Appendix E to Consent Decree

*Annex 1 to
Statement of Work
for Removal Actions
Outside the River*

*Documentation Related to
On-Plant Consolidation
Area Activities*

Pittsfield/Housatonic River Site
General Electric Company
Pittsfield, Massachusetts

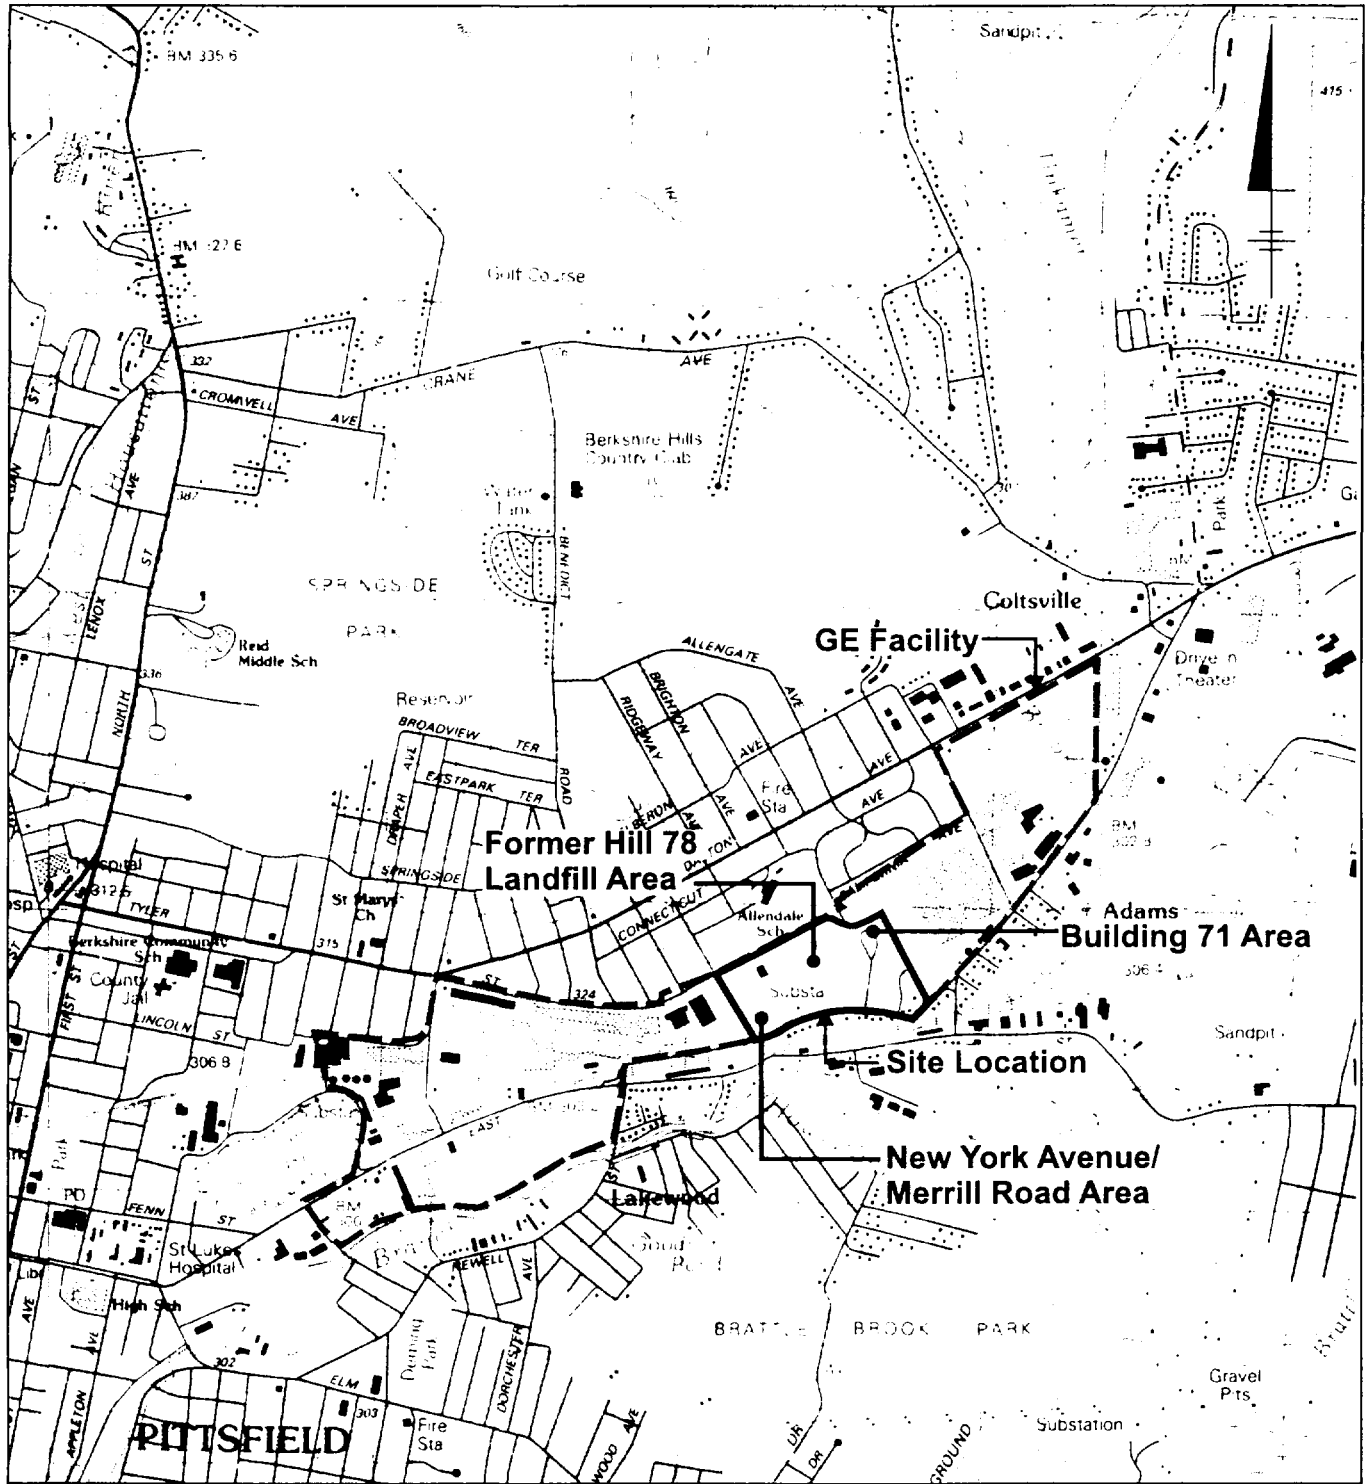
27. Figure 1: The Site Location Map does not identify the facility per the definition of the CD.
28. Figure 3: Define the thickness of the flexible membrane liner and sub base material. The EPA has recommended a 60 mil. flexible membrane.

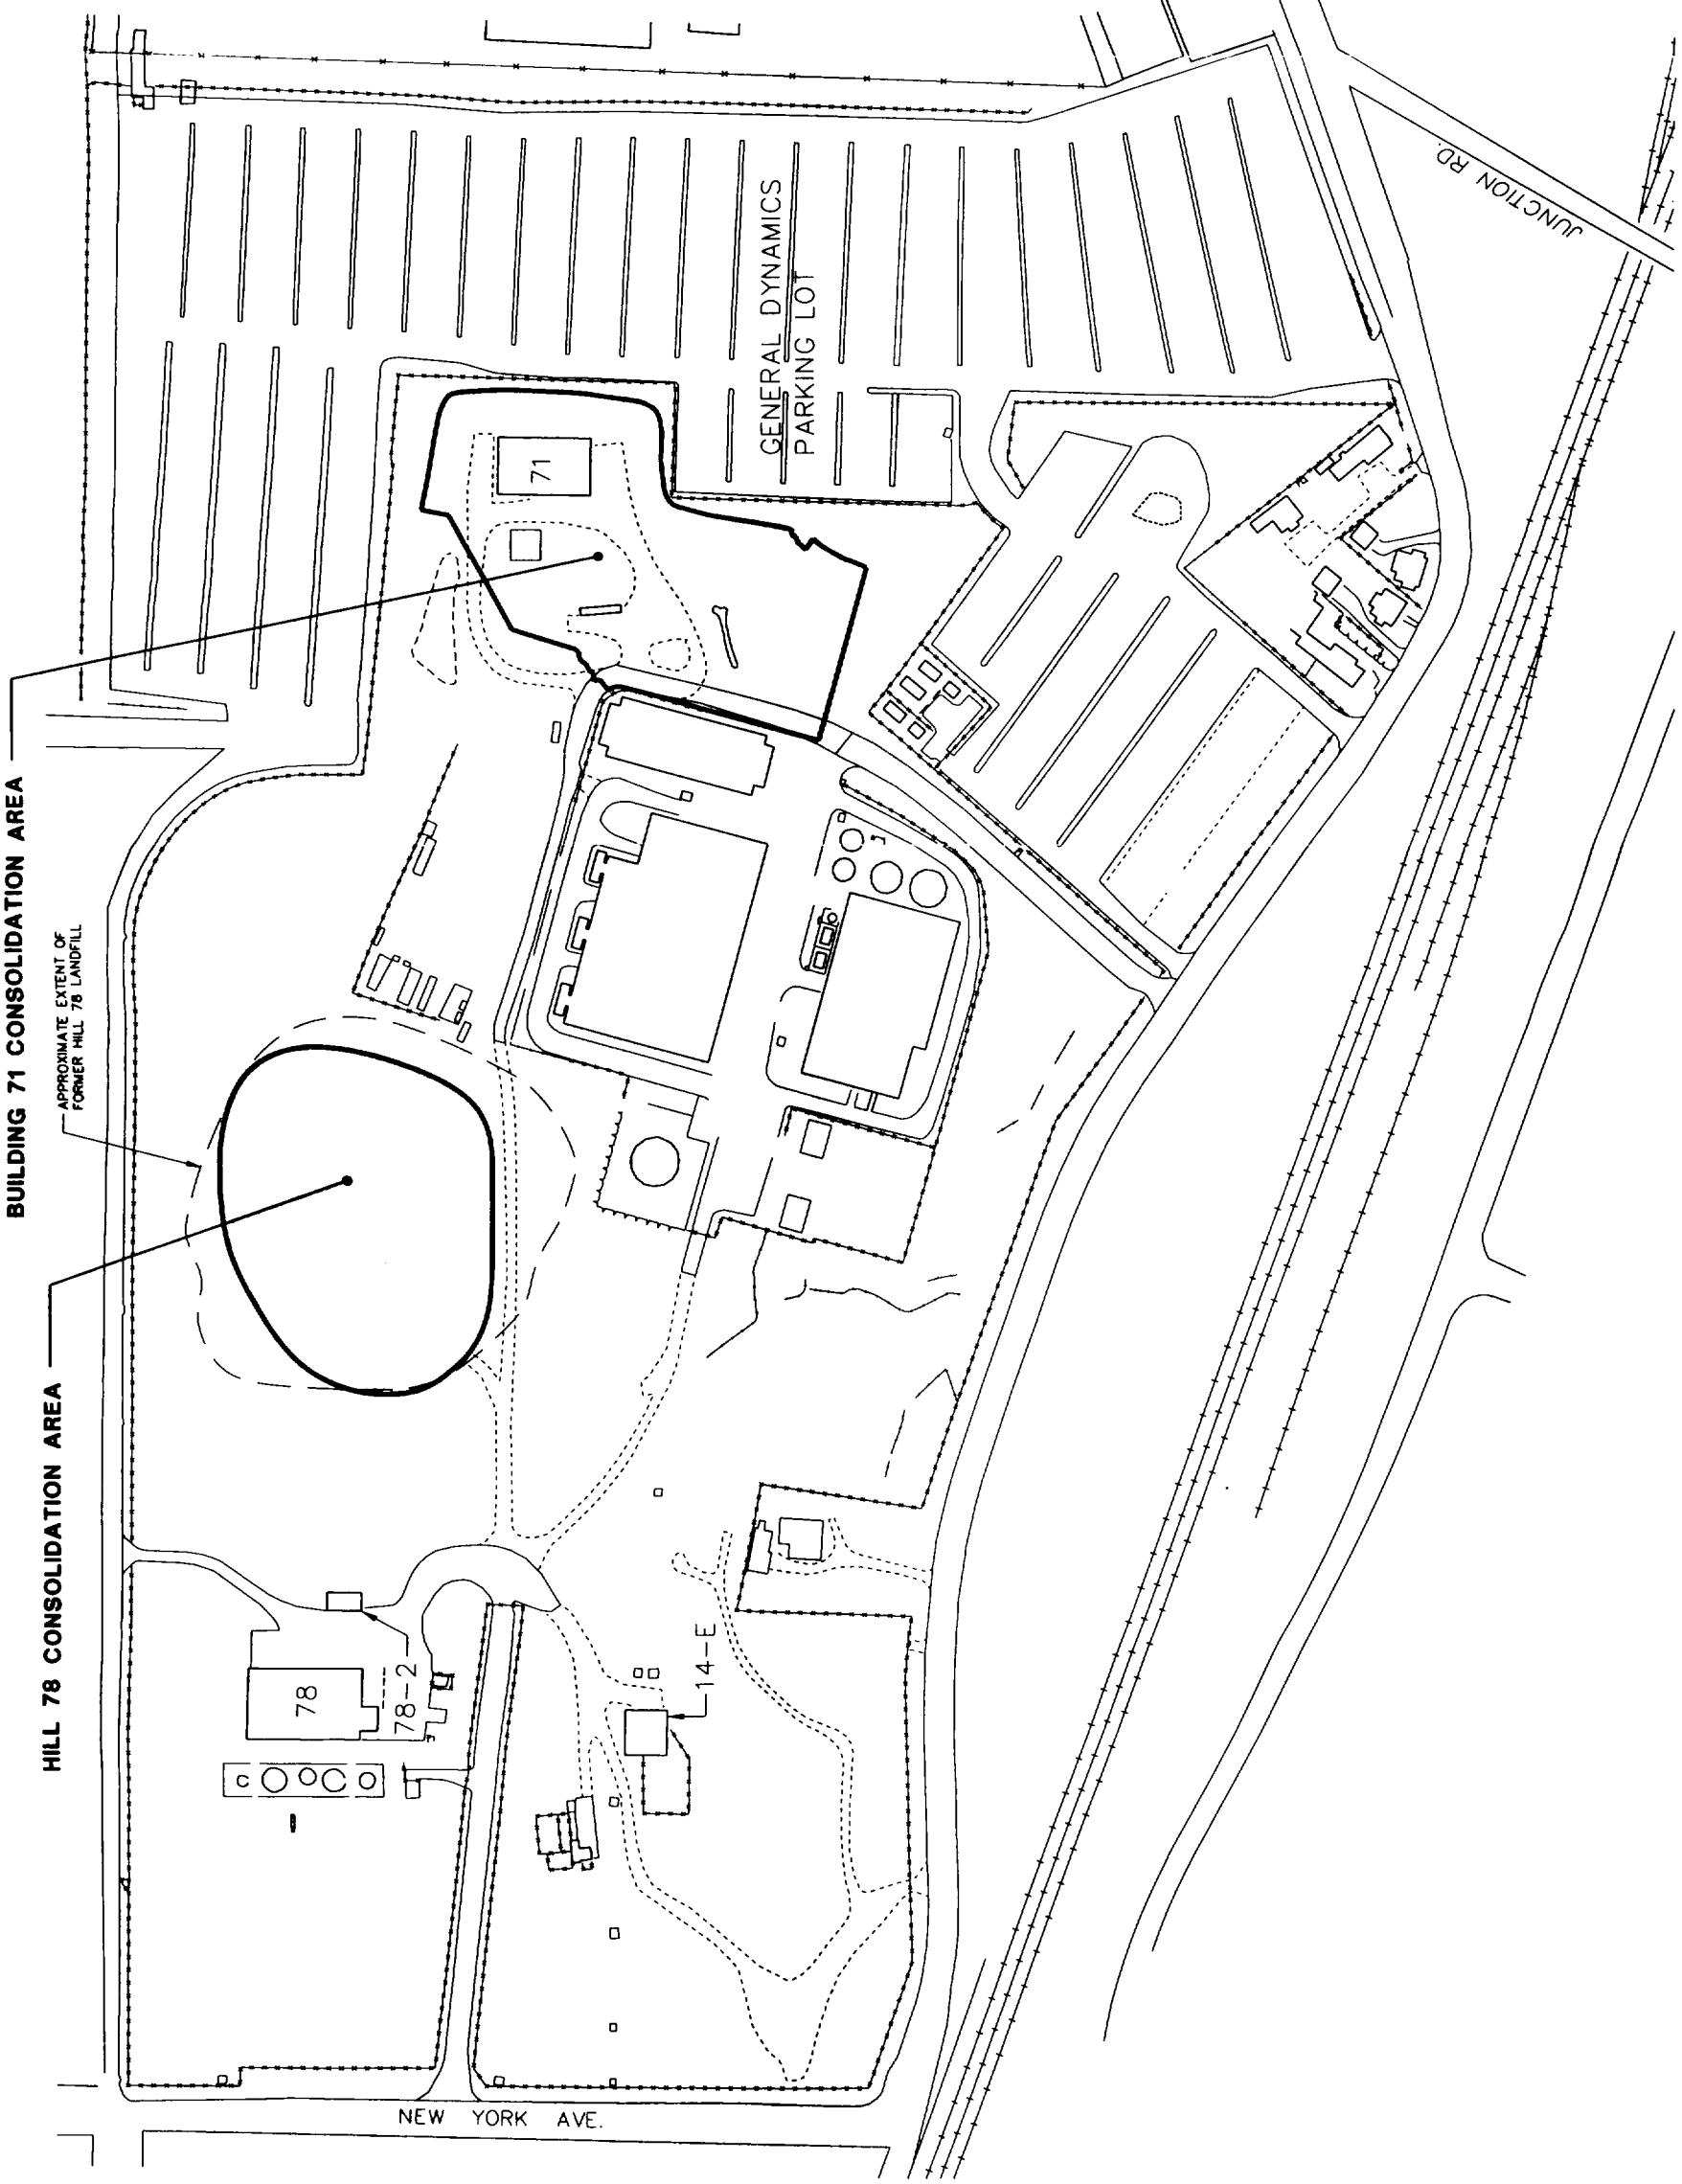
29. Figure 7: Identify in the figure and text the inclusion of the Altresco well in the groundwater monitoring program.
30. Figure 9: Define the proposed truck route for depositing material in the consolidation areas.
